# UNITED STATES PATENT AND TRADEMARK OFFICE

APPLICATION NO.	FILING DATE	FIRST NAMED INVENTOR	ATTORNEY DOCKET NO.	CONFIRMATION NO.
10/537,674	06/06/2005	Chris Wyland	US02 0511 US	5157

<b>Office Action Summary</b>	<b>Application No.</b> 10/537,674	<b>Applicant(s)</b> WYLAND, CHRIS	
	<b>Examiner</b> Eduardo A. Rodela	<b>Art Unit</b> 2826

### DETAILED ACTION

*Figure 1, Jacobs, magnified to show the tape structure.*

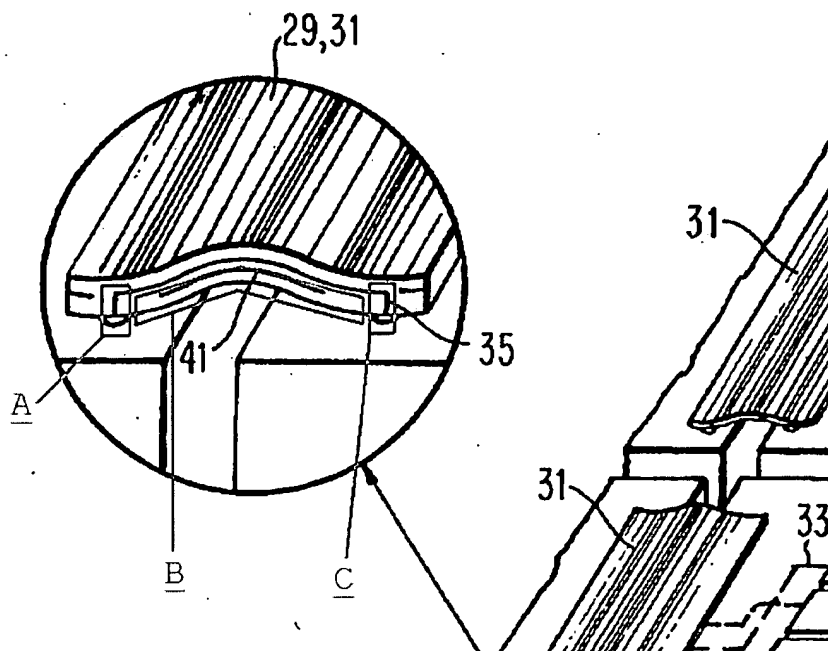
section of the first conductor, the second length shorter than the first length, the dielectric material being attached to the first conductor at about the midpoint of the first length, leaving a first gap and a second gap of the first conductor exposed [Fig. 1, magnified below: shows the electrical conductor 35 with a length longer than the dielectric portion below it, labeled by the examiner as B, with a gap for the via connects A and C to externally connect line 35].

components bonding area to another components bonding area, which includes providing a ground connection (the ground pad of the integrated circuit being connected with the ground ring of the substrate, already having been rejected in claim 1) [Fig. 1, magnified below: shows the electrical conductor 35 with a length longer than the dielectric portion below it, labeled by the examiner as B, with a gap for the via connects A and C to externally connect line 35, column 13: lines 6-21, "...thin film lines 35 in decal 29,31 interconnections. The decals 29, 31 are made of a low dielectric flexible material..."].
